Memorandum

To	Christopher Croucamp, Urbis	From	Juan Lewis, Aurecon
Copy	Mishelle Yam, NEXTDC	Reference	P521243 NEXTDC S4
Date	2026-03-17	Pages (including this page)	4
Subject	Confirmation of Servicing Strategy LOT 305 NEXTDC S4 Data Centre– Infrastructure, Hydraulic Services and Hazardous Goods

To	James Cameron	From	Mark Cheng
Copy	Juan Lewis	Reference	P521243
Date	2026-03-19	Pages (including this page)	8
Subject	NEXTDC S4 – Substation transformer noise study

Figure 6-1 Substation configuration used for the SSDA noise model

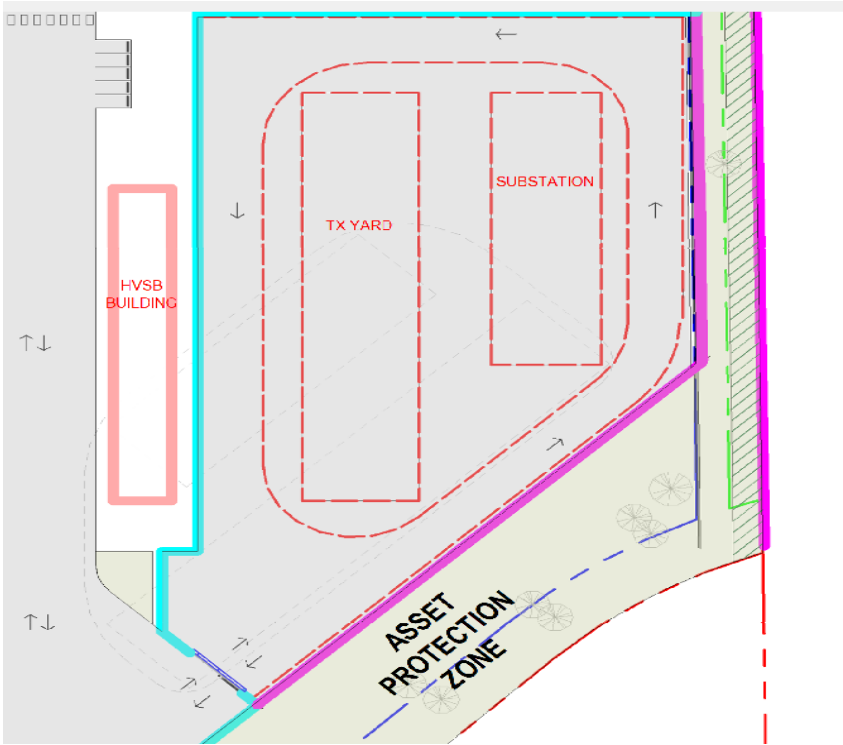
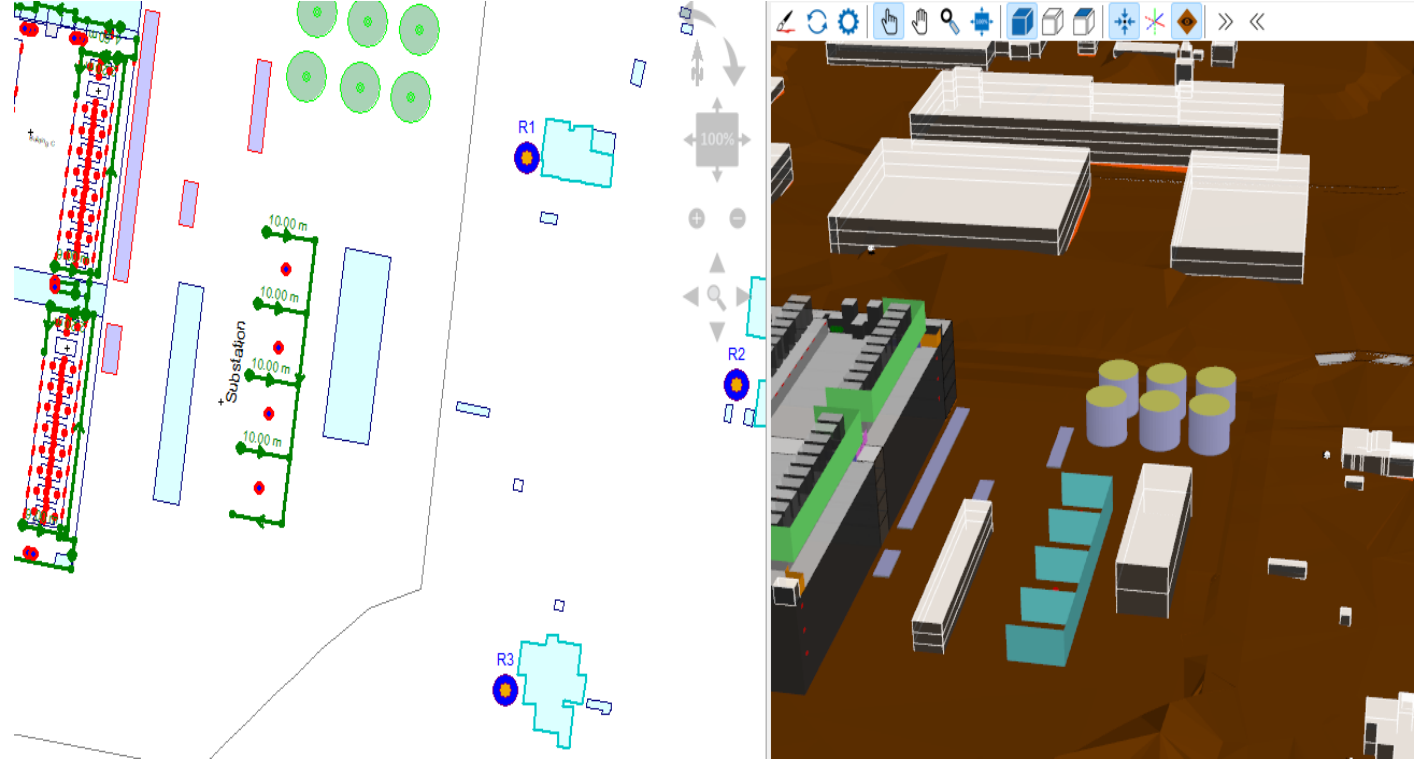
Figure 6-1 and Figure 6-2 show the SSDA RTS configuration which is based on the concept design drawings dated 11th March 2025. In this configuration, the transformer yard is located closer to the Substation building and it is noted that the transformer yard has been modelled with fire walls separating each transformer. Further, the HVSB building has been modelled as a building height of 9.4m above ground level.

Figure 6-3 Investigated noise wall scenarios

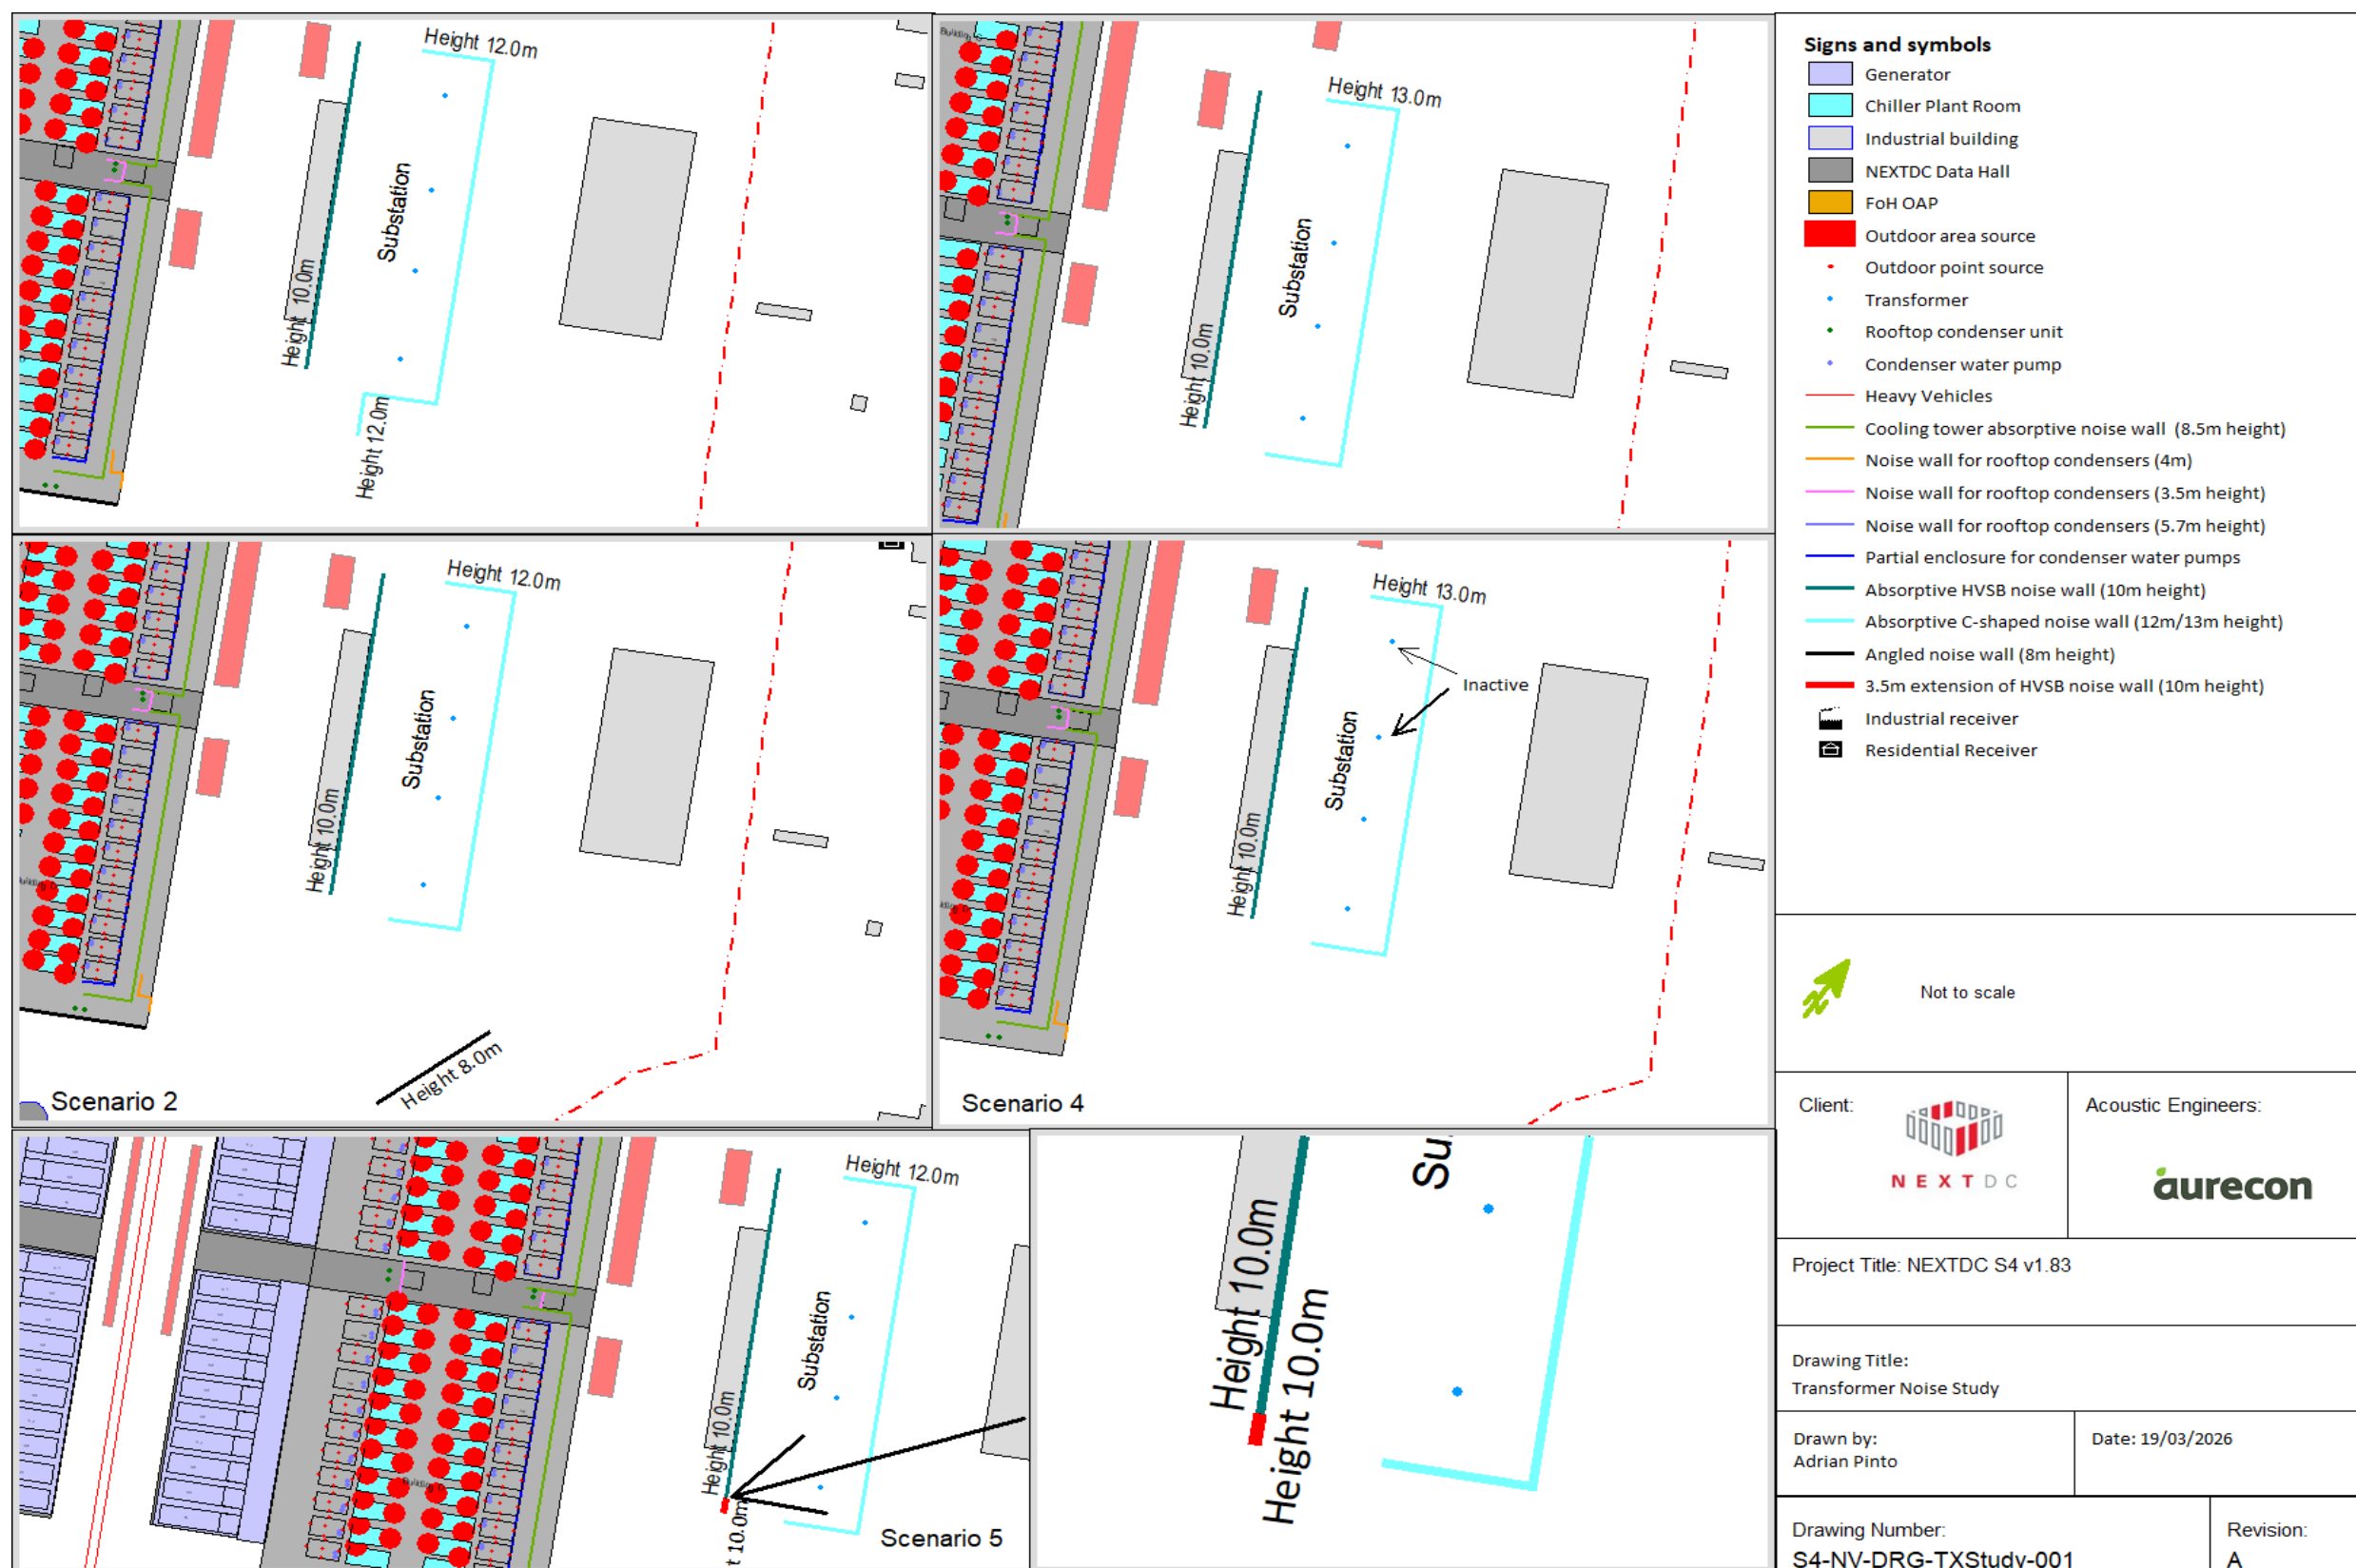
- Install a minimum 8 m high angled wall to the south of the transformer yard near the batter zone (Scenario 2), or extend the HVSB noise wall by 3.5 m toward the south (Scenario 5). Refer to Figure 6-3 for noise wall extent and orientation.

- To further reduce the predicted noise level at receiver R4, installation of an 8m high angled noise wall to the south of the transformer yard near the batter zone or extension of the HVSB noise wall by 3.5 m toward the south, as shown in Figure 6-3, is also required. Note this measure was not proposed in the SSDA model or submission.

- Install a minimum 8 m high angled wall to the south of the transformer yard near the batter zone (Scenario 2), or extend the HVSB noise wall by 3.5 m toward the south (Scenario 5). Refer to Figure 6-3 for noise wall extent and orientation.
